Model		CD510R, Rex1040						Volt/Hz	Date of Modification	Serial Number	
Modified Article		Print Pressure Cam						C201 - 22		After Mar. '91	
Reason for Modification		To ensure the printing quality on the leading part									
								C201 - 24		After Mar. '91	
Draw No.	Old Parts No.		New Parts No.	Description	A.B.C.	Q'ty Used Old → New	Inter-change-ability	Part needed for replacement by new part		Parts Catalog	
					Rank			Part No.	Description	Index No.	Page
	C2005560		C2075560	Print Pressure Cam		1 → 1	X/O			7 3	19 7

<b>Model</b>		SS810/830, Ges5110						<b>Volt/Hz</b>	<b>Date of Modification</b>	<b>Serial Number</b>	
<b>Modified Article</b>		Print Pressure Cam									
<b>Reason for Modification</b>		To ensure the printing quality on the leading part									
Draw No.	Old Parts No.		New Parts No.	Description	A.B.C.	Q'ty Used Old → New	Inter-change-ability	Part needed for replacement by new part		Parts Catalog	
					Rank			Part No.	Description	Index No.	Page
	C2005560		C2075560	Print Pressure Cam		1 → 1	X/O			19 5	25 9

<b>Model</b>	SS810/830, Ges5110	<b>Volt/Hz</b>	<b>Date of Modification</b>	<b>Serial Number</b>
<b>Modified Article</b>	Ink Antechamber			
<b>Reason for Modificat

**[ Old ]****[ New ]**

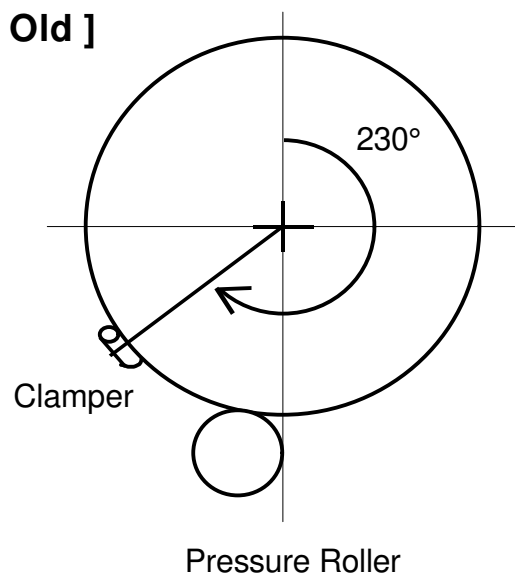
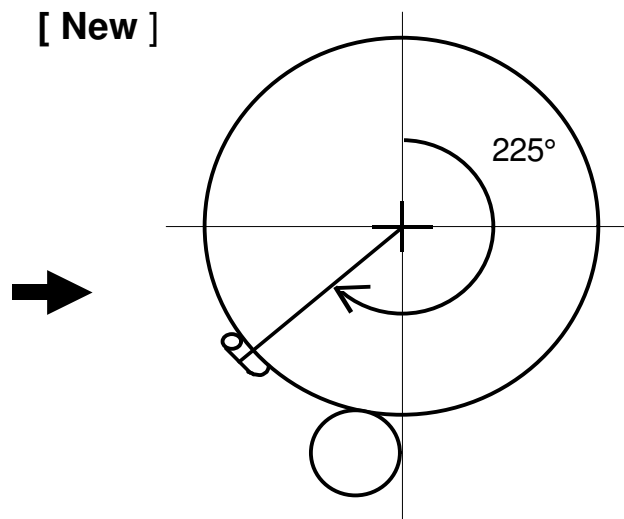
To ensure the printing quality on the leading part of the paper, the shape of the print pressure cam has been changed. If there is solid fill image on the leading part of the original and the printing speed is high (4 or 5 step), a low density horizontal band may appear about 30 millimeters from the leading edge of the print. This is caused by pressure roller bound when the pressure roller contacts the drum surface. The new print pressure cam applies the print pressure to the pressure roller 5 degrees faster in the drum rotation angle. (The pressure roller contacts the drum about 7 millimeters before the leading edge of the paper.)

NOTE: When the new print pressure cam is installed, the exit pawl timing is also changed. (The exit pawl approaches the drum 5 degrees faster in the drum rotation angle.) Therefore, it is necessary to make sure that the exit pawl does not contact the master clasper. (Readjust the exit pawl timing if necessary.)

Pressure Roller Contact

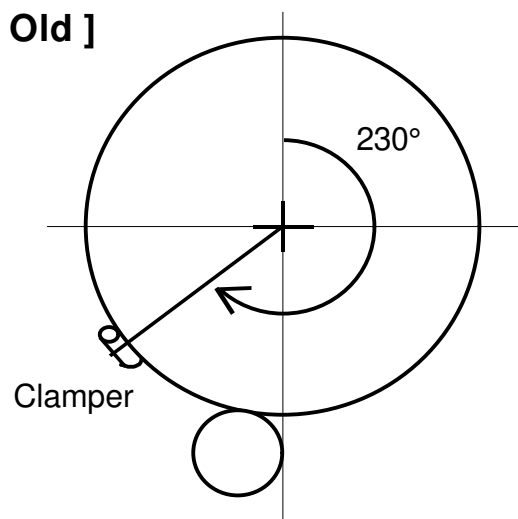
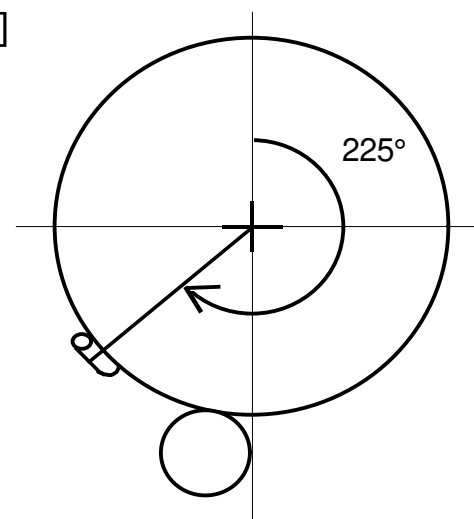
To ensure the printing quality on the leading part of the paper, the shape of the print pressure cam has been changed. If there is solid fill image on the leading part of the original and the printing speed is high (4 or 5 step), a low density horizontal band may appear about 30 millimeters from the leading edge of the print. This is caused by pressure roller bound when the pressure roller contacts the drum surface. The new print pressure cam applies the print pressure to the pressure roller 5 degrees faster in the drum rotation angle. (The pressure roller contacts the drum about 7 millimeters before the leading edge of the paper.)

NOTE: When the new print pressure cam is installed, the exit pawl timing is also changed. (The exit pawl approaches the drum 5 degrees faster in the drum rotation angle.) Therefore, it is necessary to make sure that the exit pawl does not contact the master clasper. (Readjust the exit pawl timing if necessary.)

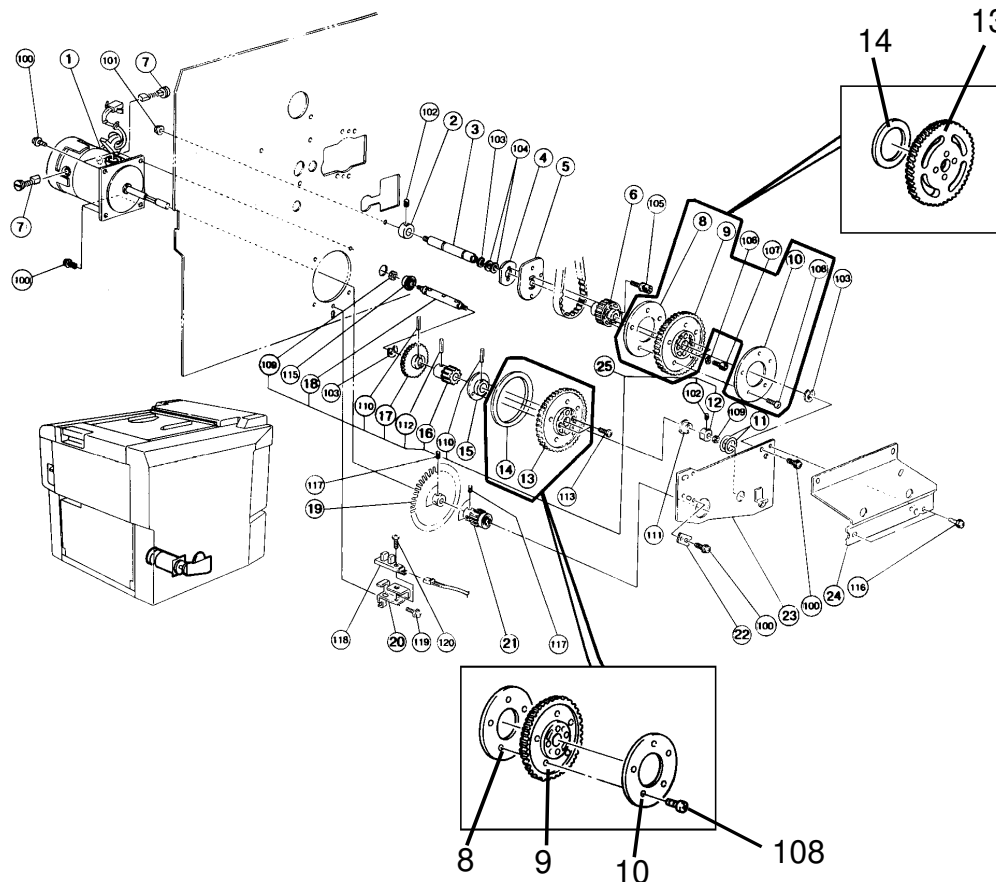
To increase durability, the material of the drum drive gears (drum side and machine side) have been changed.

Old Part Number	New Part Number	Description	Interchangeability	Page	Index
C2012218	C2132218	Stud & Gear - 30T	X/O	7	1
C2032330	C2132330	Drum Drive Gear/Pulley Ass'y	X/O	7	36
C2034560	C2134560	Rear Drum Flange	X/O	35	41
